# LAVALLEE BRENSINGER ARCHITECTS

Fie	ld	Re	port

The Park Danforth

Portland ME Field Report No: 17

Typical Joint between curtainwall and floor; See Item #17.3

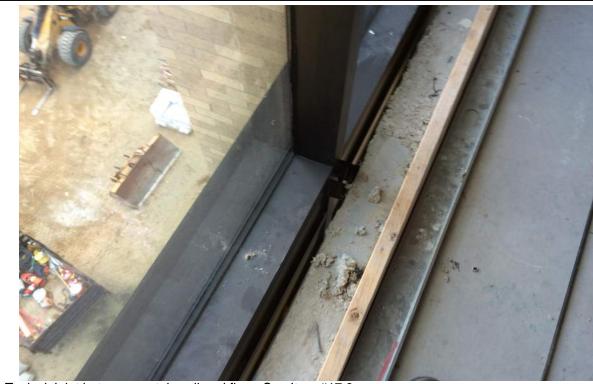
Perimeter firestopping detail at curtainwall and floor joint still needs to be installed. Reference Photo 10A.
